**Planning, Development
and Transportation**
Transportation Planning
305 Chestnut Street
PO Box 1810
Wilmington, NC 28402-1810

■ **COASTAL FINANCE OFFICES [TRC Plan Review]**

☞ Initial Review Note ☞

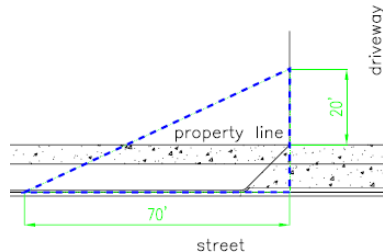
1. The proposed commercial driveway does not have the standard taper width for a commercial driveway. Please revise to show 13' tapers.
2. Driveways for lots along major thoroughfares must at least 75' offset from property lines to the curb line. A variance may be required for this project.

3. Driveways shall be City-standard ramp-type driveways. Show appropriate City standard detail(s) on plan. [[Chapter VII ,Detail SD 3-03.3 & 3-03.4\) CofWTSSM](#)]
4. Dimension driveway widths and tapers. [[Sec.18-529 CofW LDC](#)]
5. The minimum two-lane driveway width is 23'. [[7-9 CofW Tech Stds](#)]

6. The proposed sidewalk along S. Kerr Avenue does not appear to meet the NCDOT Clear Zone Requirements for a 45 mph roadway with greater than 6000 vehicles per day traffic volume. The clear zone requirements will require either vertical separation or a minimum clear zone of 18' to 20'.
7. The site plans do not show the correct City of Wilmington 20'x70' Sight Distance Triangles. Show and apply the City's 20'x70' sight distance triangle at each driveway on the site plan and landscaping plan. [\[Sec.18-529\(c\)\(3\)CofW LDC\]](#) Add a note indicating that all proposed vegetation within sight triangles shall not interfere with clear visual sight lines from 30"-10'. [\[Sec.18-566 CofW LDC\]](#)

8. Please dimension the backing stub. [\[Chapter VII ,Detail SD 15-12 CofWTSSM\]](#)
9. Please verify that a Fire Truck can safely enter and exit this site. Provide a turning movement analysis of a Fire Engine at this location.
10. Please verify the parking space dimensions for the proposed parking. The minimum standard vehicle parking space size is 8.5' in width by 18' in length. Some of the parking stalls do not appear to meet the minimum 8.5' width.
11. Although not a requirement, it is requested the Applicant consider adding some bicycle parking. Please add the proposed number to the site data table and graphically indicate on the plans the location of bike parking. [\[Sec.18-528 CofW LDC\]](#)

12. The proposed Accessible Aisle that is adjacent to Van Accessible Parking Spaces does not appear to meet ADA requirements. The Van Accessible Access Aisle should be located on the Right Side of the vehicle. Please revise the location of the Accessible Aisle and Handicap Ramp.
